DESCRIPTIVE REPORT
(HYDROGRAPHIC)

Type of Survey ... Hydrographic
Field No. ... WH-10-2-71
Office No. ... H-9203

State ... Delaware
General Locality ... Cape Henlopen
Locality ... Harbor of Refuge & Vicinity

OFFICE OF MARINE SURVEYS AND MAPS
MARINE CHART DIVISION
HYDROGRAPHIC SURVEY REVIEW

HI-Fix Layout
 WH-10-2-71
 WH-5-1-71
 Overlay to NOS Chart 1109
 NOAA Ship Whiting
 Project OPR 492
 Delaware Bay
 Cdr. C.H. Nixon, Comdg.

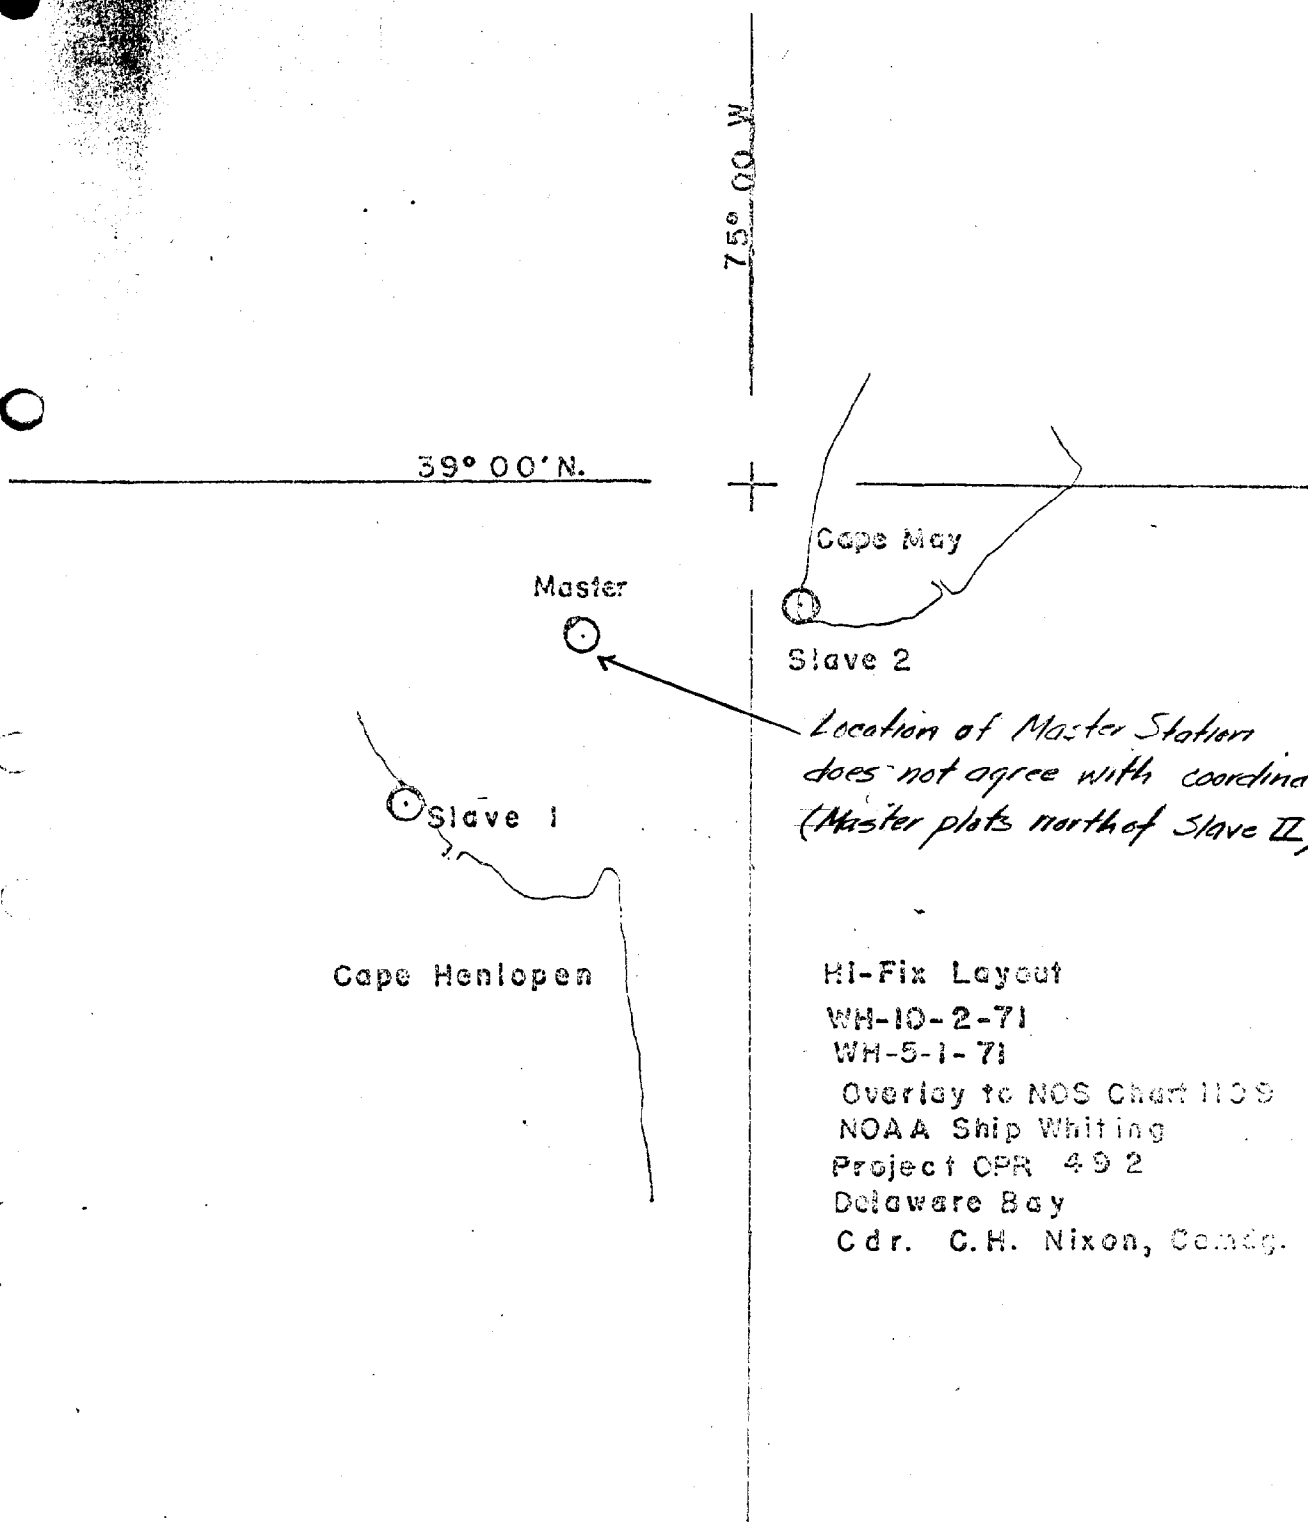
*Location of Master Station
does not agree with coordinates.
(Master plots north of Slave II).*
